Office Action Summary	Application No. 10/519,546	Applicant(s) SUGGATE, TREVOR ROSS	
	Examiner Gary Hartmann	Art Unit 3671

DETAILED ACTION

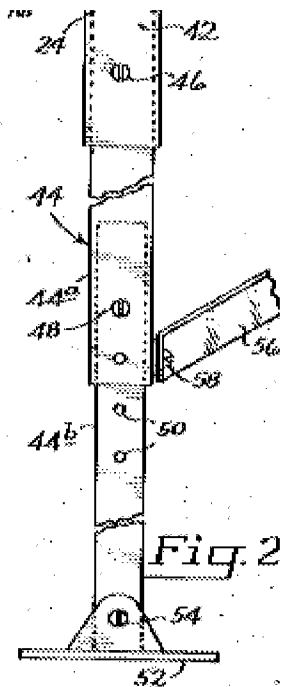
Greenwood discloses a deck support having a prefabricated movable member (44a) engageable with a corresponding elongate member (44b). The movable member (44a) has an extension (56, 38) arranged to directly support the deck (Figure 1, for example).

There is a pivotable foot (52) extending from an end of the elongate member (44b).

The movable member (44a) includes a handrail support (42, 24, 76) which support prefabricated handrails (60, 62, 64, 66).

There are folded deck segments (24).

There is a pin (48) for locating the movable member (44b) relative to the elongate member (44a).
